## RECOMMENDATIONS FOR HARBOR PROJECT VIBRATION TESTING

Quantum Corporation  
Larry Witting, Mike Strzepa, Ken Kan, Charles deJesus  
4/27/99 ( Vib-harbor.doc)

Reference #1: "Computer Chassis Vibration Test Overview" by Tom Irvine  
Dated 2/28/99

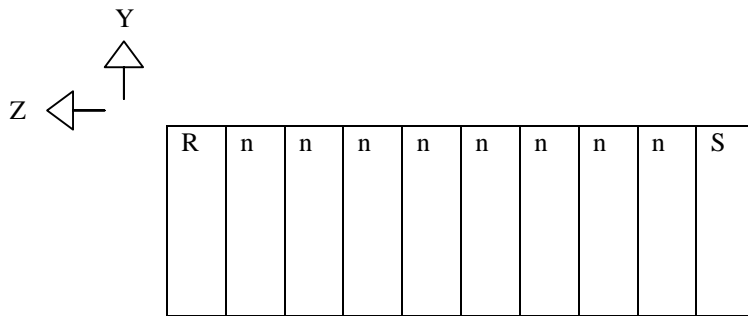
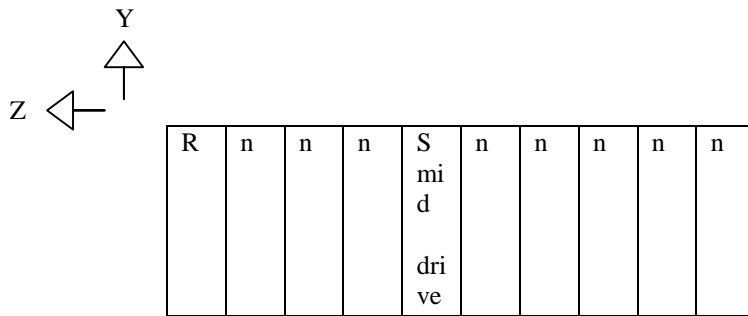
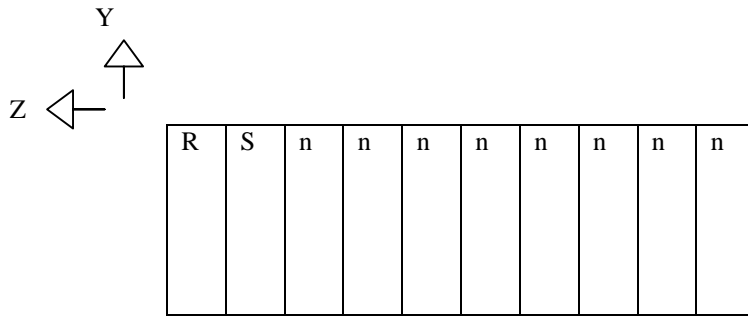
The location of the Drive/Wrapper assemblies in the Dock and whether the drive is operating or not, will have an effect on the other assemblies in terms of resonance. A simplified test location scheme for Ten 1.6" drives is described below. For 1.0" drives locations would be similar. It is assumed that the vibrational effects are symmetrical i.e. a positional configuration on one end is the same as the other.

"S" indicates the Source operating drive that produces the vibrational excitation.

"R" indicates the Recipient drive that receives the vibrational excitation.

"n" indicates slot is filled but drive is not operating.

RECEIVER DRIVE AT END; SOURCE DRIVE VARIES POSITION:

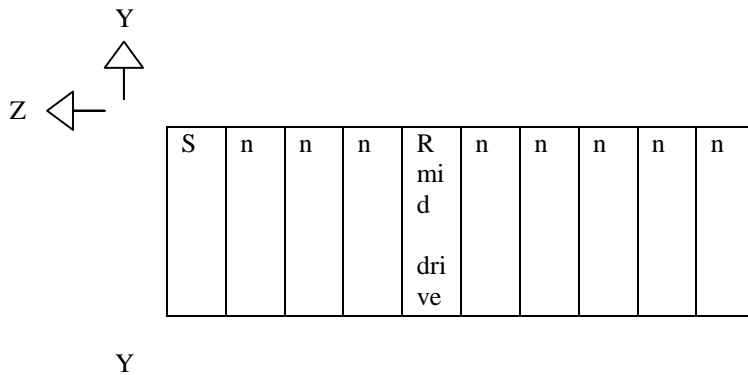
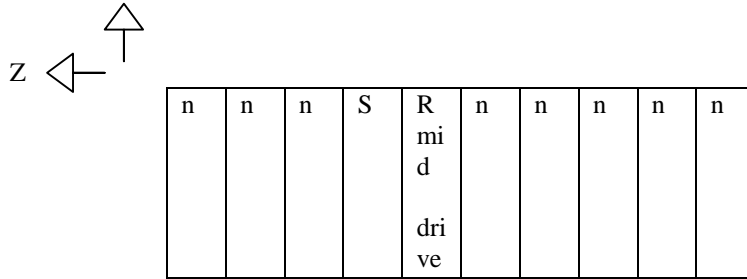
OPERATING MODE: S AND R DRIVES ARE SEEKING

RECIPIENT DRIVE VARIES POSITION, ALL OTHERS ARE SOURCE DRIVES:

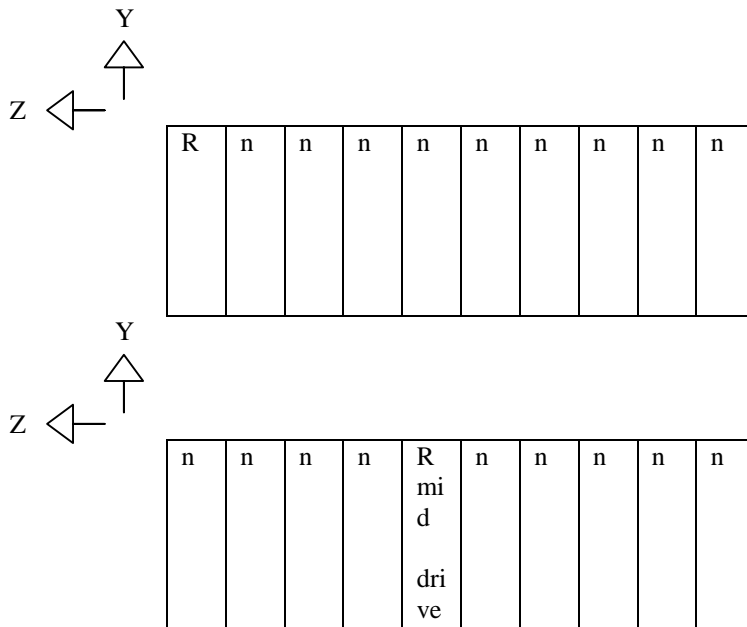
- TRANSLATION – The translation forces and accelerations along the X and Y axis should also be measured by placing the accelerometers appropriately in conjunction with the rotational measurements. The rotation and translations tests are the same and are run together. The external vibration translation measurements are again compared to the internal PES measurements.
- IDLE SYNC UP – When a number of drives are running together at constant speed (idling) slight variations will cause the frequencies to go in and out of synchronization.
